The concept plan for Grange Park is well liked however we would appreciate if the following points would be considered as the plan is revised during the detailed design phase.

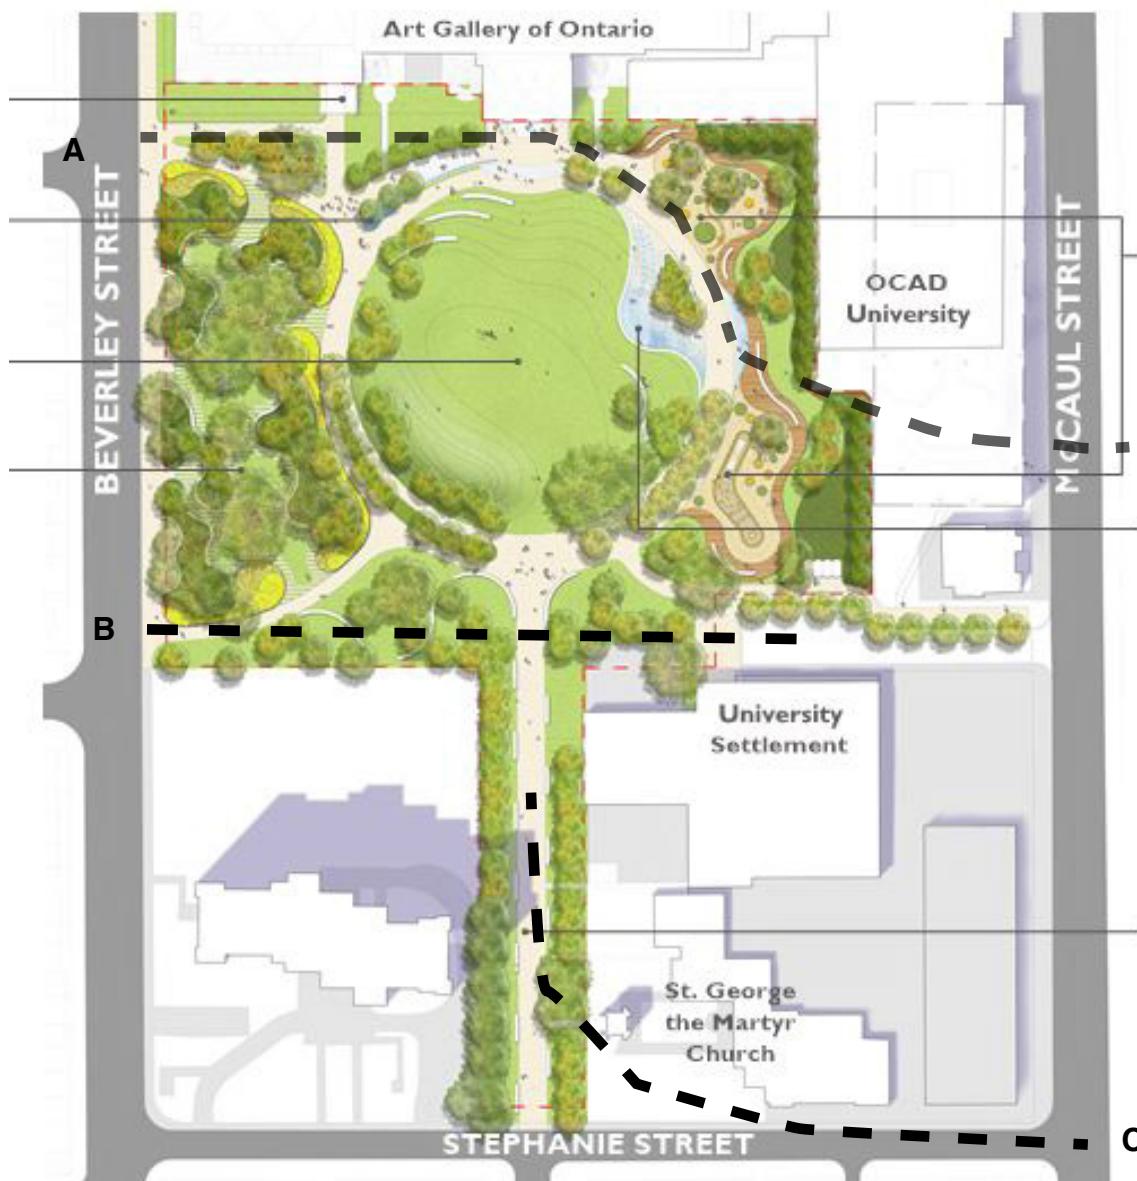
Pedestrian and cyclist flow will likely degrade the sod as people will attempt to maintain their route from the south west entry across the southern end of the park. Perhaps a smaller path serving this desire line can be considered. (LINE B)

The connection between the NW corner of the park and access to OCAD may be interrupted by the southern playground. This point is related to the connection between the park and Butterfield Park. (LINE A)

Existing well-worn desire path can be used as guide to formalize a path there.

(LINE C)
